ADOBE DAM

DAM, OUTLET WORKS AND SPILLWAY

PERIODIC INSPECTION

REPORT NO. 1

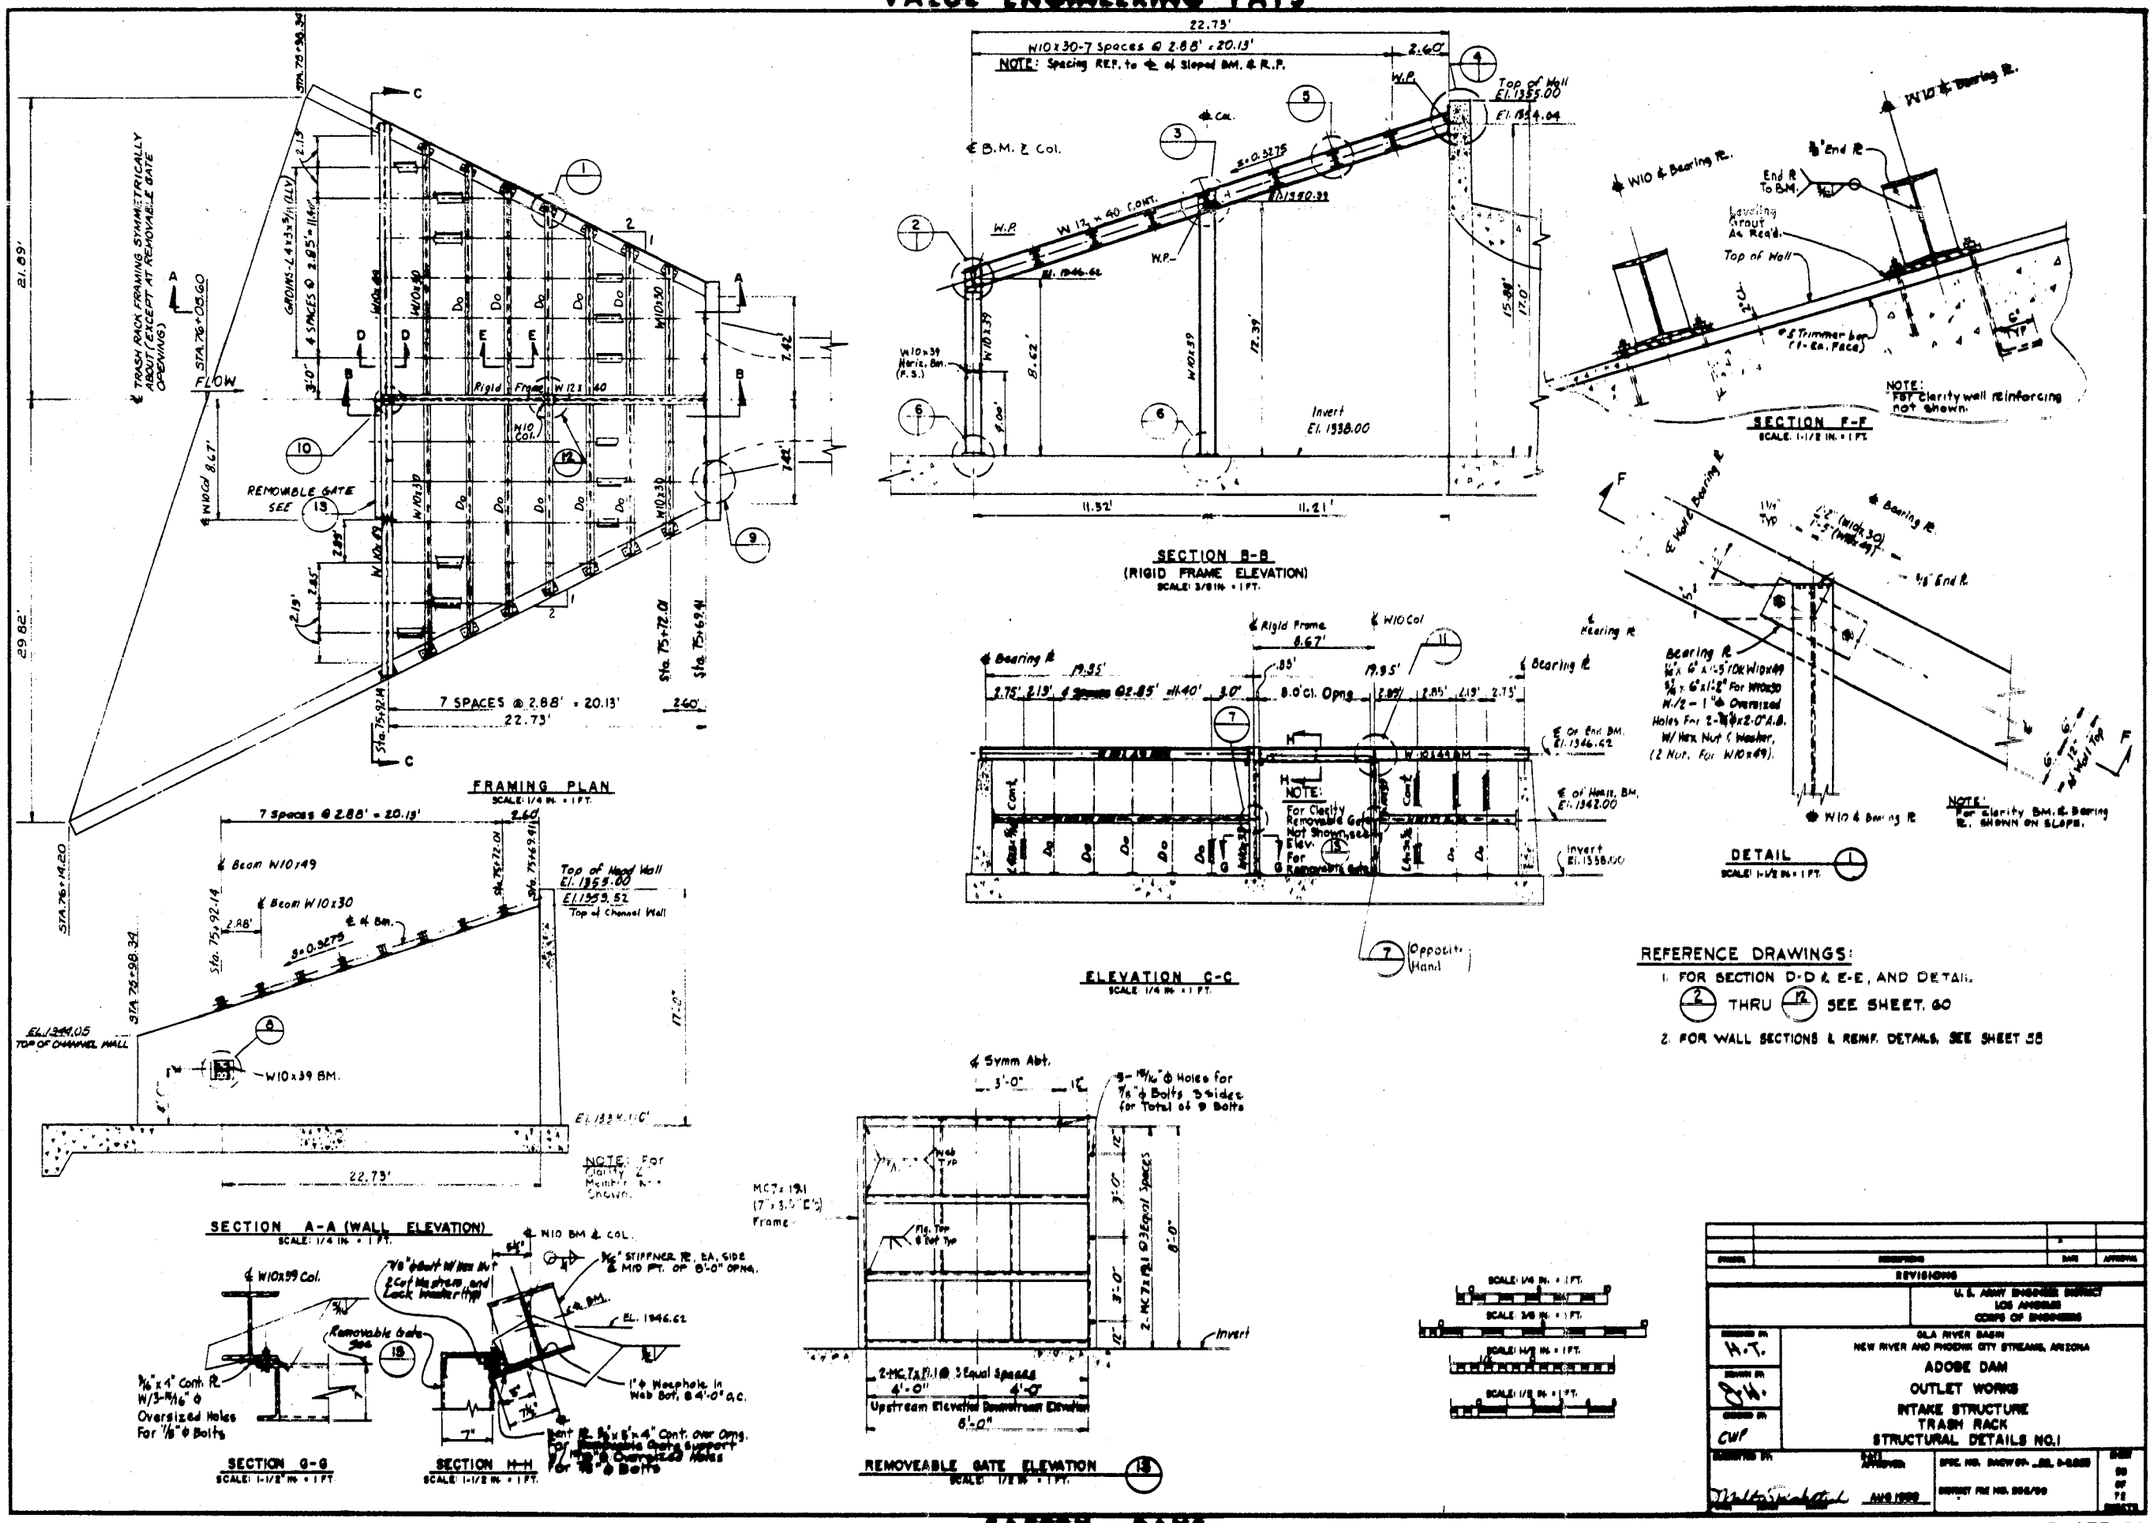
b. Plates in the inspection brochure did not show the trash rack or the concrete baffle blocks in the energy dissipator. There was some discussion as to the effectiveness of the latter. Both should be shown in the first inspection report.
